HOWELLS FERRY SUBDIVISION

APPLICATION NUMBER 16 DATE September 15, 2011

REQUEST Subdivision

DETAIL SITE PLAN

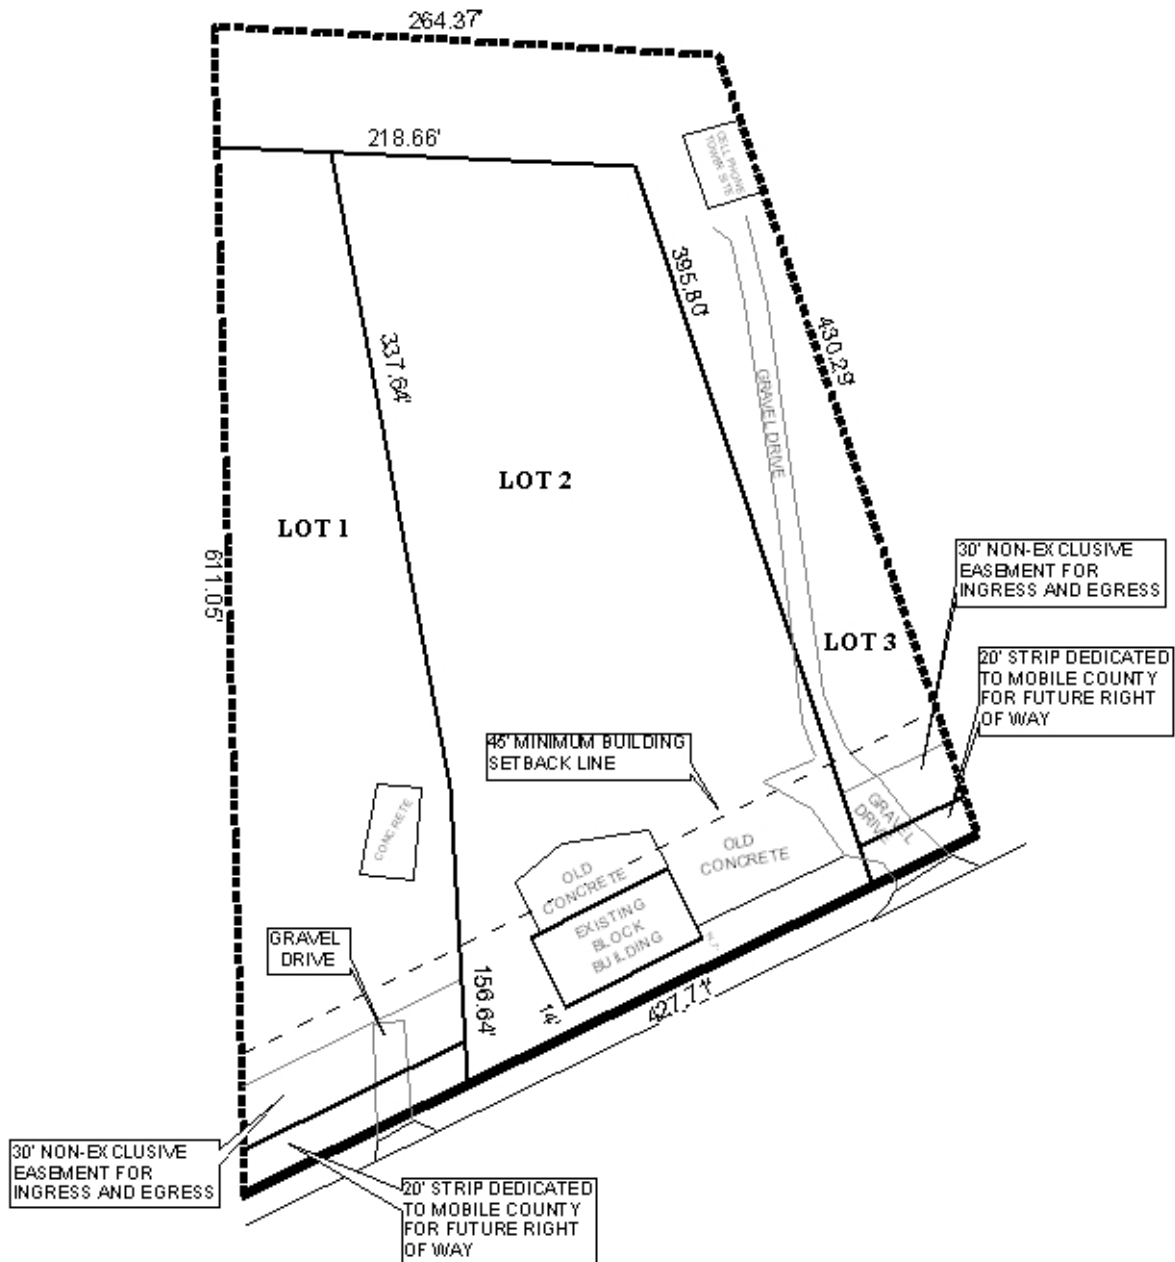
The site fronts onto Howells Ferry Road, a major street with a non-compliant 60' right-of-way; therefore, dedication would be required along Lots 1 and 3, to provide 50-feet from the centerline of Howells Ferry Road. As illustrated on the preliminary plat a non-compliant block structure exist within the 25-feet minimum building setbacks; therefore, the placement of a 45-foot setback (25-feet minimum building setback + 20-feet future dedication) to allow future widening of Howells Ferry Road in accordance with the Major Street Plan component of the Comprehensive Master Plan.

As a means of access management, a note should be required on the Final Plat, if approved, stating that the development is limited to two curb cuts on Howells Ferry Road, with the size, location and design to be approved by County Engineering and conform to AASHTO standards.

The lots, as proposed, meet the minimum required lot size. As on the preliminary plat, the lots should be labeled with its size in acres and square feet, or a table should be furnished providing the same information on the Final Plat, if approved.

As proposed, Lot 3 would be a "flag" lot with a 60-feet wide, 395-feet "pole". Section V.D.1. of the Subdivision Regulations does not allow flag lots unless such are common within the area or in the case of a family division of property. It should be noted that no "flag" lots are within the vicinity of the proposed development. Therefore, a waiver of Section V.D.1. may be justified in this instance. Section V.D.3. of the Subdivision Regulations states that the maximum depth of

any lots, exclusive of unusable land shall not be more than 3.5 times the width at the building setback line. Using this calculation, the proposed Lot 3 is approximately 220-feet deeper than allowed. If approved, Lot 3 will require a waiver of Section V.D.3. of the Subdivision Regulations. There are some irregularly-shaped lots within the area, and some which exceed the depth-to-width ratio, but none of which have been approved by the Commission.

Based upon the preceding, this application is recommended for denial, due to the following reasons:

- 1) Section V.D.1. of the Subdivision Regulations does not allow “flag” lots unless such are common within the area or in the case of a family division of property.
